# IEEE 802.1Qau Reaction Point Tag: Issues & Questions

Bruce Kwan & Ashvin Lakshmikantha

IEEE Plenary Meeting (Denver)

July 15, 2008

# Bridge Behavior: Open Questions

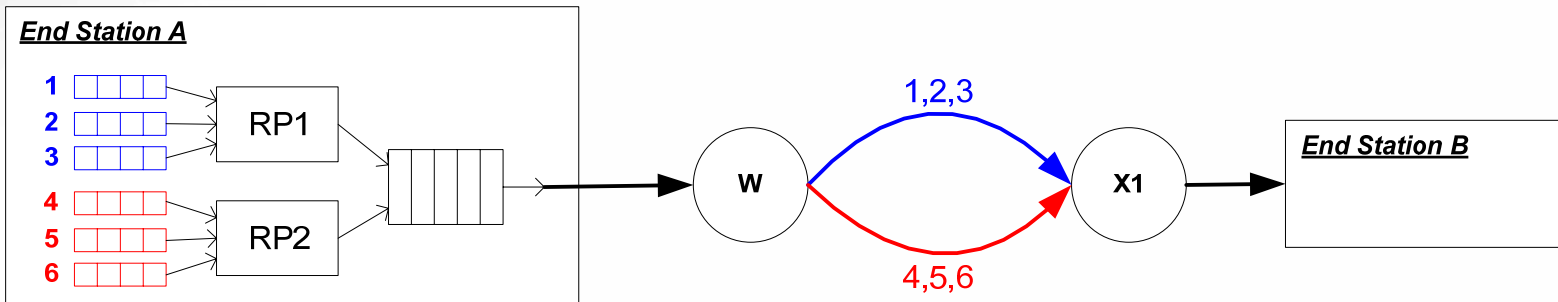
- **Defining Bridge Load Balancing Behavior**

- What is being proposed for the bridge behavior? Need to define it now and rather than leaving it undefined.
- At present, the standard does not dictate the bridge load balancing algorithm. Doing so would limit vendor differentiation.

# Fate Sharing Issue Remains

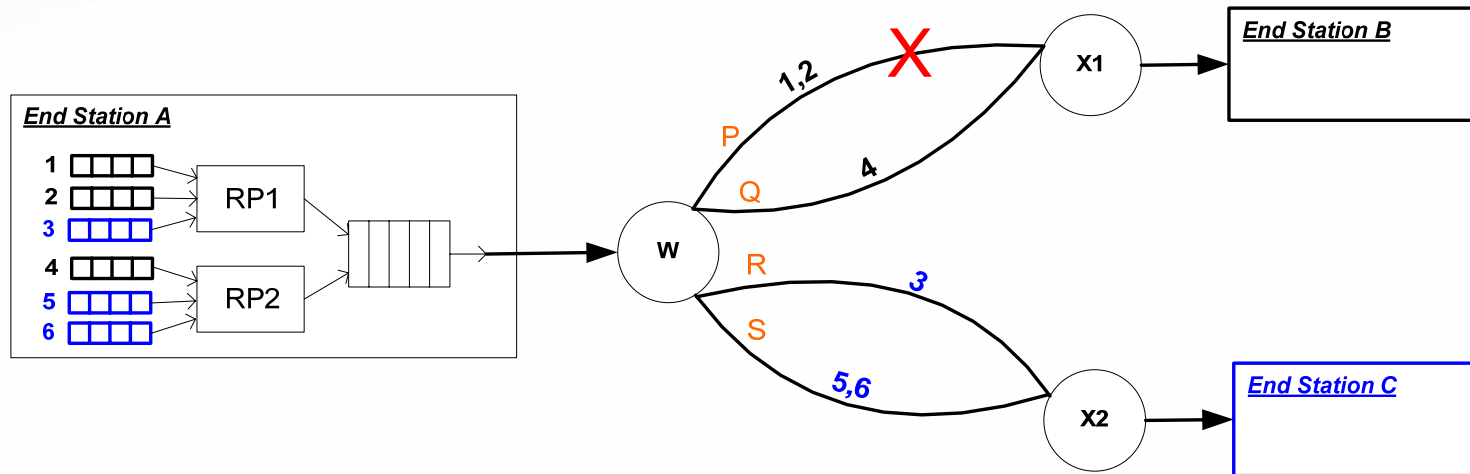
When congestion occurs on path P, the rate of flows associated with RP1 will be slowed down. Innocent flow 3 will be impacted.

Fate sharing is not addressed with the RPID under this common scenario where RP's contain flows with different destinations.

# RPID, QCN and Mice Flows Fate Sharing Degradation

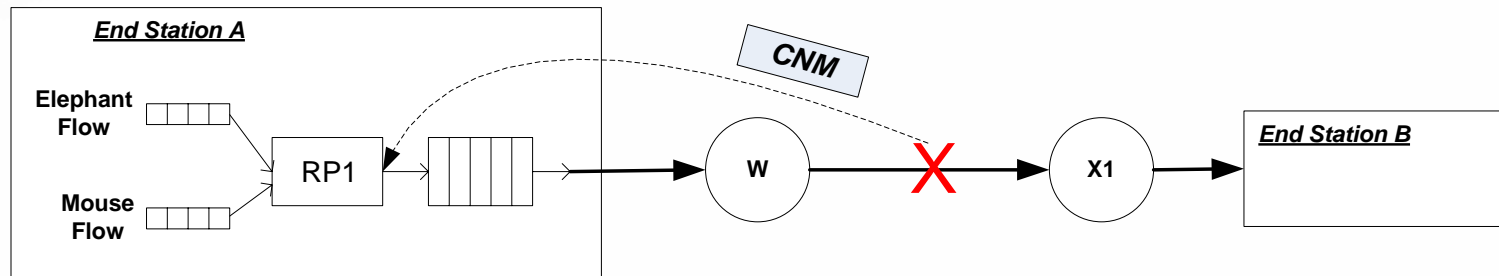
- Impact of RPID on QCN and Mice Flows

- RPID assigned to all incoming flows
- If an RP is being congestion managed, any mice flows mapped to that RP will result in fate sharing and slow delivery of mice flows
- Reduced utilization of the network

# Load Balancing Degradations

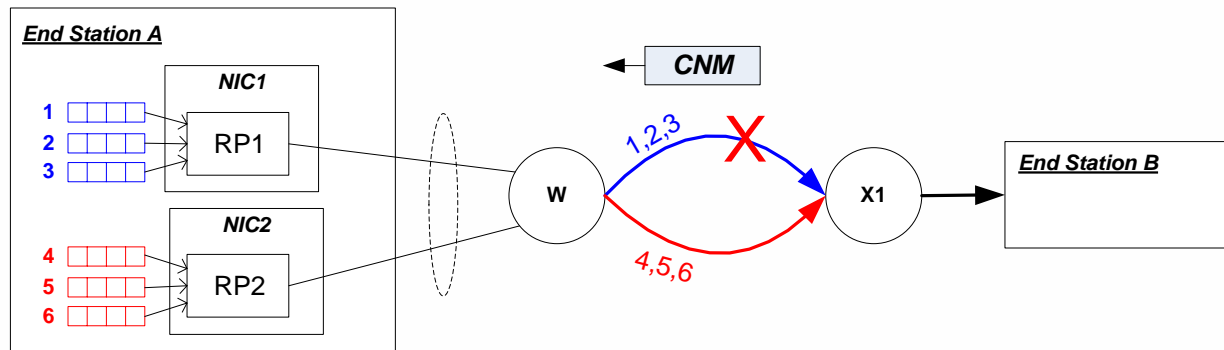
- To achieve desired behavior, one approach would be to perform hash based load balancing based only on the RPID

- Load balancing microflows can yield even load balancing across paths
- Load distribution based on the coarse-grained definition of a flow (RPID) can lead to degraded load balancing behavior

# Bridge Behavior: Open Questions

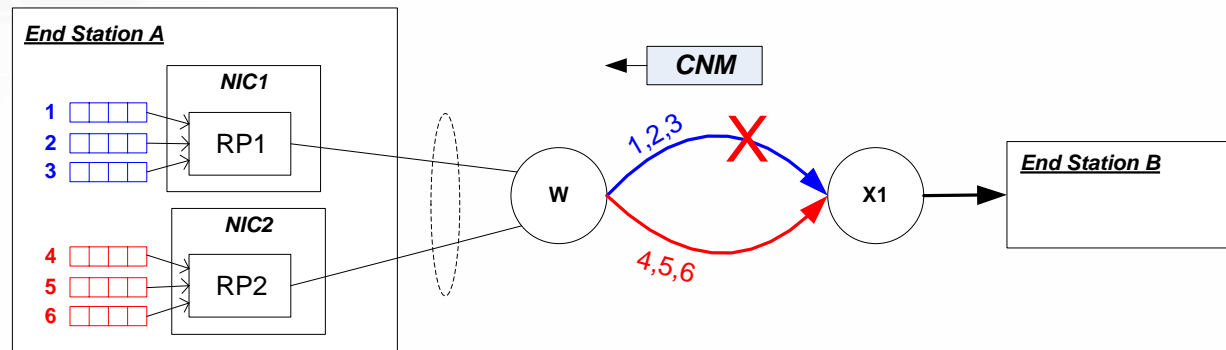
- **Bridge Behavior**
  - What is the impact on the bridge?
- **Support May Lead to Increased Cost/Complexity**
  - RPID to Port Mapping Table
    - To achieve stated goal, edge bridge connected to NICs requires a mapping table from RPID to port
    - When a CNM message arrives, the mapping table can be used to resolve how to direct the CNM to the correct NIC
  - Populating the Mapping Table
    - Manual Configuration, or
    - Protocol definition needed to “learn” the binding between RPID and port
